SERVICE BULLETIN NO. MSB1078-186/3

ATA-Code: 55-20 Elevators and Trim tab
 Inspection of elevator trim tab arm

Fig. 1

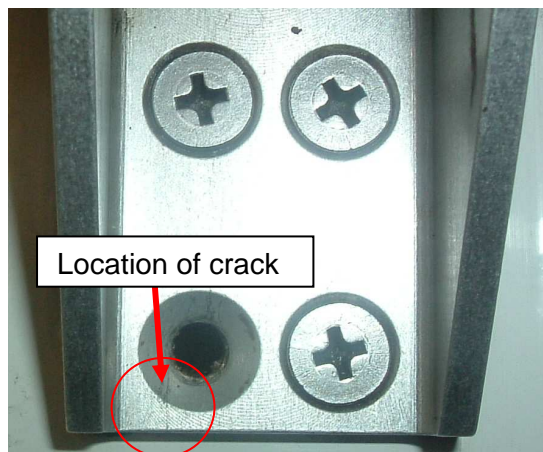
Grob received a report from a fleet operator that an elevator trim tab arm P/N 115E-3758 was found cracked from a rear mounting hole (either L/H or R/H) to the rear edge of the trim tab arm.

Dye penetrant check of defective items revealed, that a visual inspection of an installed item mandated with MSB1078-186 at original issue may not be sufficient to detect every crack on the bracket (Fig. 2).

Investigation of defective parts revealed corrosion cracking as cause for cracks. To prevent future cracking, the Trim Tab Arm 115E-3758 is replaced by 115E-3758/1, which is manufactured from an alloy resistant to corrosion cracking. In addition to that, shaping is improved and a paint coat is applied.

Fig. 3

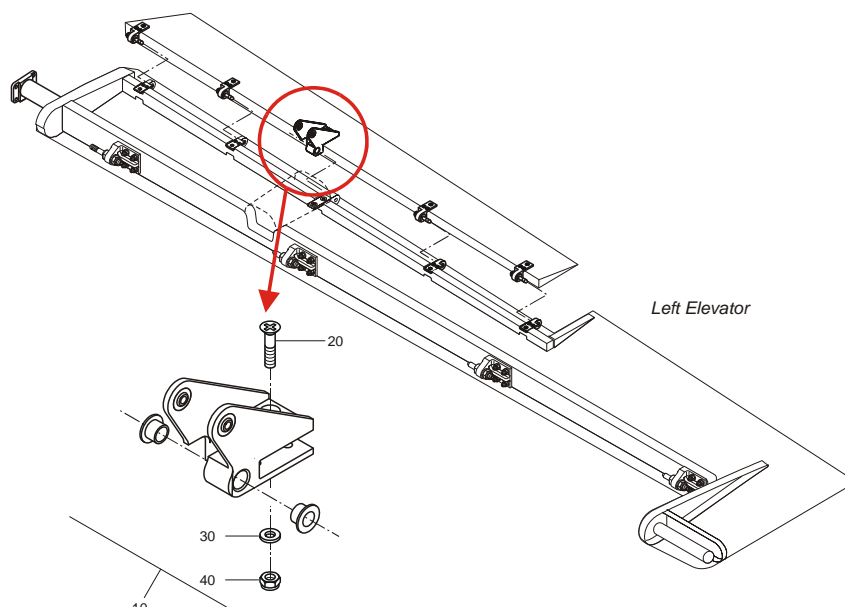
- 1.8.1 Ensure that the aircraft is safe for parking I.A.W. G 115E AMM chapter 10-10 and G 115EG Job Guide in analogy.
- 1.8.2 Inspect elevator trim tab operating arm for signs of cracking, especially both upper and lower surfaces from the rear bolt mounting holes to the rear of the operating arm.
- 1.8.3 Remove trim tab I.A.W. G 115E AMM chapter 55-20 para. 3B and G 115EG Job Guide in analogy
- 1.8.4 Remove trim tab arm (item 10 in Fig. 3) by removing nut, washer and bolt (item 20, 30, 40 in Fig. 3)

1.8.13 Remove trim tab arm (item 10 in Fig. 3) by removing nut, washer and bolt (item 20, 30, 40 in Fig. 3)

1.8.14 Install new trim tab arm **P/N 115E-3758/1** (item 4 of List 2.2) using bolt, washer and new locking nut (item 20, 30, 40 in Fig. 3). Apply correct torque value I.A.W. G 115E AMM chapter 20-10 and G 115EG Job Guide in analogy.
